Peer Review of Draft Report “Analysis of Evaporative On-Board Diagnostic (OBD) Readiness and DTCs Using I/M Data”

February 24, 2014

This report details the peer review of the subject draft report, *Analysis of Evaporative On-Board Diagnostic (OBD) Readiness and DTCs Using I/M Data (December 11, 2013)*, which documents results from ERG's analysis of light-duty gasoline-powered vehicle On-board Diagnostic (OBD) evaporative emissions control system (evap) diagnostic trouble codes (DTCs) using inspection and maintenance (I/M) program data. A number of independent subject matter experts were identified and the process managed to provide reviews and comments on the new evaporative data analysis. This peer review process was carried out under EPA's peer review guidelines¹.

Figure 2. Percent of Inspection Cycles with Evap Monitor Ready at Lease-Once by Age for State B

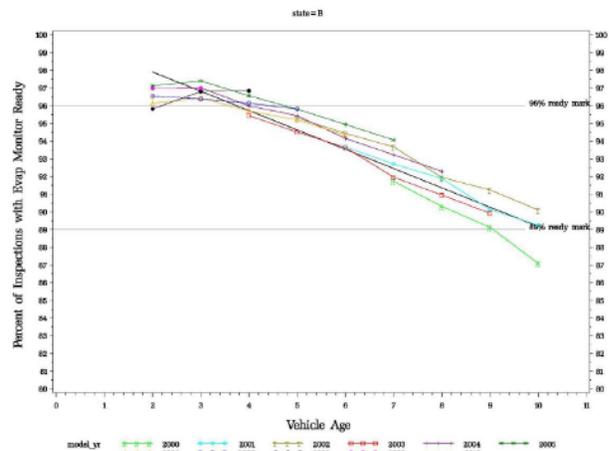
Author: mmccarth Subject: Comment on Text Date: 12/17/2013 2:08:24 PM
 As an added thought, does showing any analysis of the percentage of total cars failing for not ready (or maybe presenting with any not ready monitors) that have the evap monitor not ready help solidify the second reason (rigorous enable criteria) as the dominant factor in lieu of alternate theories like the first reason (masking)? e.g., if virtually all cars that fail for not ready or have at least one monitor not ready indeed have evap as not ready, doesn't it lead to the likely conclusion that the masking reason only could be valid if evap DTCs are so rampant that they dwarf all other failures put together and virtually everybody that has an evap DTC has figured out how to mask it based on how few of evap DTCs are left in initial inspections relative to how many would have had evap DTCs if most evap not ready cars were actually cars with Evap DTCs that were being masked prior to initial inspection?

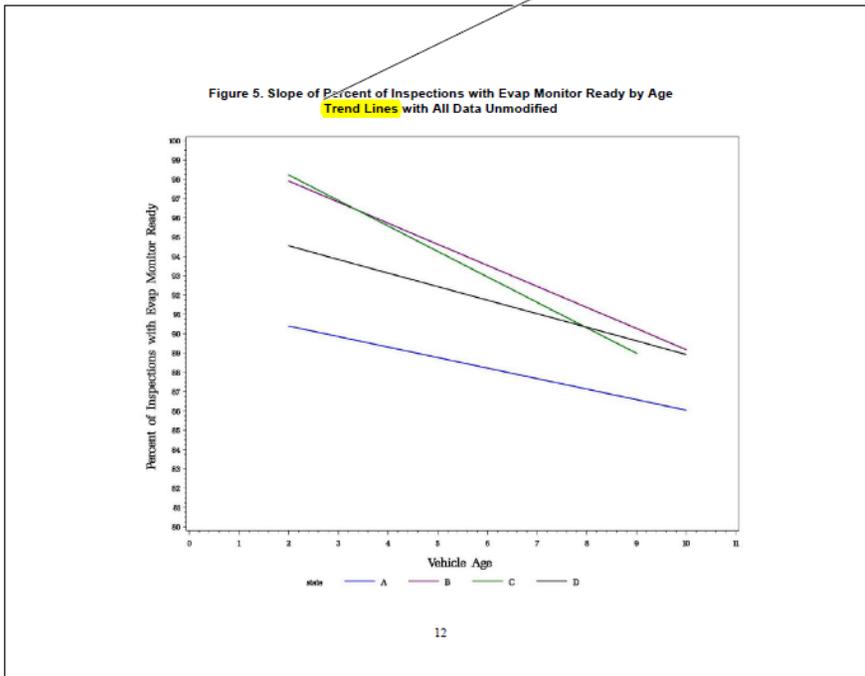
Maybe you'll get to this later but how does this trend compare with other aspects like fail rate of cars by age or presence of a DTC by age? (e.g., is the evap readiness rate doing its own thing independent of other stuff or is it for example mirroring the increased fail rate of older cars?)

Author: mmccarth Subject: Comment on Text Date: 12/17/2013 1:55:37 PM
Might be worth adding 'markers' to the lines to aid a reader in black/white or hard copy in distinguishing the various state trend lines from each other.

Figure 5 - In figure 5, the rate of decrease in readiness with model year for states A and D are almost identical, but A is 5% lower.

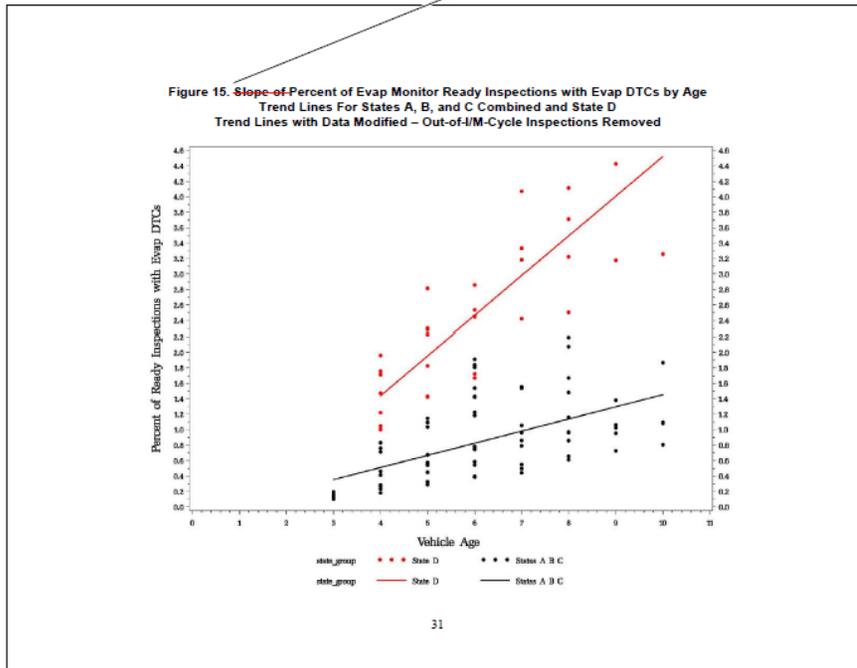
Author: mmccarth	Subject: Comment on Text	Date: 1/10/2014 10:14:01 PM
Isn't State A's rate substantially flatter than B and C? Is it close enough to call it a very similar rate of increase?		
Author: mmccarth	Subject: Cross-Out	Date: 12/17/2013 2:42:27 PM

- Author: mmccarth Subject: Comment on Text Date: 12/17/2013 2:47:53 PM
Pretty repetitive to previous paragraph and reader has to scan back and forth to discern the differences you are highlighting (range of DTC rates at 4 and 8 years old vs average DTC rate at 4 and 8 years old). Might be better to combine into one paragraph to repeat less and have the reader follow better (e.g., the percentage of tests with a DTC was between x and y with an average of z, etc.)
- Author: mmccarth Subject: Comment on Text Date: 12/17/2013 2:49:15 PM
sentence is worded awkwardly especially near the end.
- Author: mmccarth Subject: Inserted Text Date: 12/17/2013 2:50:03 PM
refine these predicted

Figure 15 - Move Figure 15 up one page so it follows where it was mentioned.
